Detailed Site Plan Dewey Property

DSP-19050-01

SUBJECT: Detailed Site Plan DSP-19050-01
Type 2 Tree Conservation Plan TCP2-042-2019-02
Dewey Property

Figure 1: North and East Elevations of Building on Parcel 1

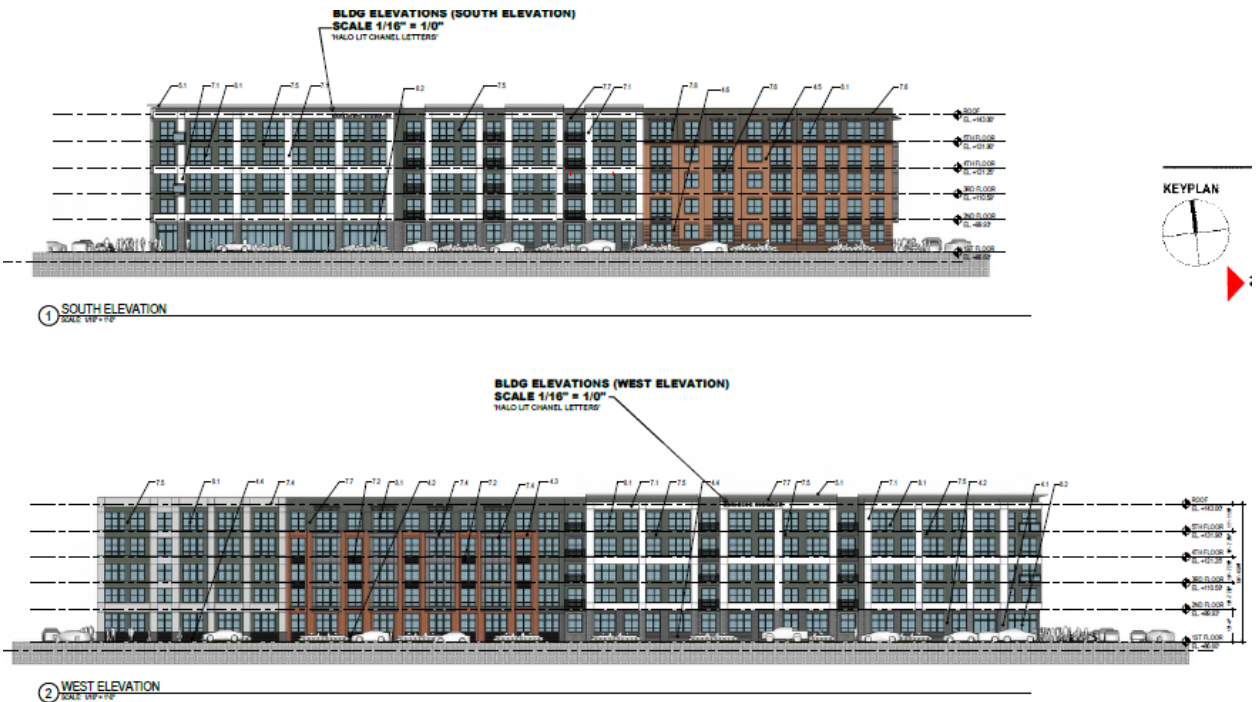
The use of cementitious panels, metal, and masonry is in line with materials used on adjacent buildings. The white, brown, and gray colors provide some contrast and diversity, as well as compatibility with the different façades and surrounding buildings. The applicant attempts to use changes in color, balconies, articulation of the mass, and other details to provide interest and break up the building. However, the building on Parcel 1 should incorporate a more colorful palette to make it more compatible with the buildings and architecture proposed on Parcels 2 and 3.
